# Access Compliance Report

## Public Rights-of-Way

Intersection ID: 31298	Main Street: SOLANO_DR	Cross Street: BERKELEY_PLACE_DR	Location: NE
ADA ID: 665D3BAD617E	Ramp Type: Perp	Initial Pass/Fail: Fail	Overall Compliance: No
Severity Score: 26.25			
Codes/Mitigation Info/Possible Solution		Field Measurements/Component Compliance

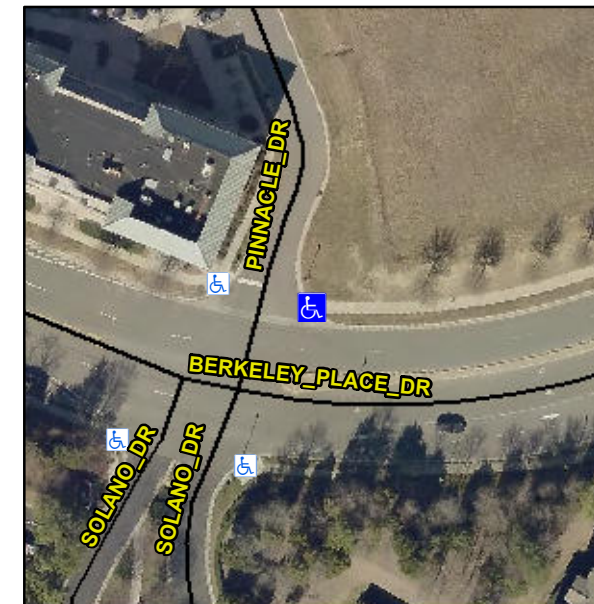
**R304.2.2, R304.5.3**

Compliance	Description	Data	Compliance	Description	Data
N/A	Ramp Length (in)	87.2	No	Ramp Slope (%)	15.7
Yes	Ramp Width (in)	73.0	No	Ramp XSlope (%)	3.6
N/A	Flare Type LT	N/A	N/A	Flare Type RT	N/A
N/A	Flare Slope LT (%)	N/A	N/A	Flare Slope RT (%)	N/A
N/A	Flare Traversable LT?	N/A	N/A	Flare Traversable RT?	N/A
N/A	Landing Length (in)	N/A	N/A	DWS Provided?	N/A
N/A	Landing Width (in)	N/A	N/A	DWS Contrast?	N/A
N/A	Landing Slope (%)	N/A	N/A	DWS Length (in)	N/A
N/A	Landing X Slope (%)	N/A	N/A	DWS Full Width?	N/A
N/A	Landing Curb? (Y/N)	N/A	N/A	DWS Offset (in)	N/A
N/A	Shared Landing?	N/A			
N/A	Gutter Ponding?	N/A	N/A	Gutter Slope (%)	N/A
N/A	Gutter Lip Ht (in)	N/A	N/A	Gutter X Slope (%)	N/A
N/A	Painted X Walk1?	No	N/A	Painted X Walk2?	N/A
	X Walk 1 Direction	To W		X Walk 2 Direction	N/A
N/A	X Walk 1 Width (in)	N/A	N/A	X Walk 2 Width (in)	N/A
	X Walk 1 Slope (%)	3.2		X Walk 2 Slope (%)	N/A
	X Walk 1 X Slope (%)	1.1		X Walk 2 X Slope (%)	N/A

**Remove & Replace Entire Ramp.**
